TECHNICAL INFORMATION

72170

- Subject** ▶ Change of Name Plate and Motor Housing,
Elimination of Rivet 0-5 and Rubber Pin 4.
- For Models** ▶ 9401, 9402
- Country** ▶ All countries
- Description** ▶ Name plate of metal have been replaced by the one of polyethylene telephthalate resin.
The tool for attaching the Name plate to Motor housing has also been changed
from Rivets to adhesive on the reverse of the Name plate itself.
Also, Rubber pin 4 has been eliminated from Motor housing.

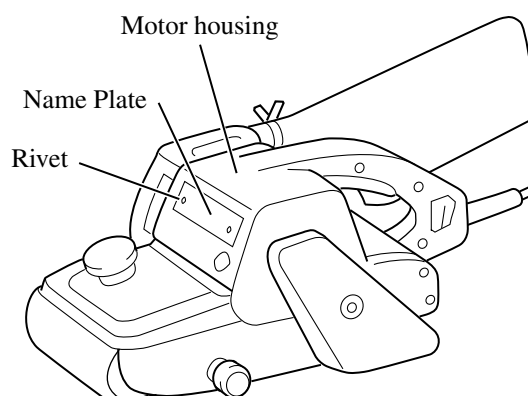
The new Motor housing doesn't have the holes for the Rivets. Therefore, replace the current Name plate by the new one at the same time.

Item No.	Current part		Q'ty	I/C	New part		Q'ty	Note
019	Name Plate 9401 811732-2		1	No	Name Plate 9401 850166-4		1	For 9401
006	Name Plate 9402 854824-4		1	No	Name Plate 9402 850176-1		1	For 9402
9401: 018 9402: 005	Rivet 0-5 953106-2		2					
022	Motor Housing 156225-5		1	Yes	Motor Housing 156225-5		1	For 9401 Part No. remains the same.
002	Motor Housing 157148-0		1	Yes	Motor Housing 157148-0		1	For 9402 Part No. remains the same.
9401: 015 9402: 072	Rubber Pin 4 263002-9		1					The component part of Motor housing
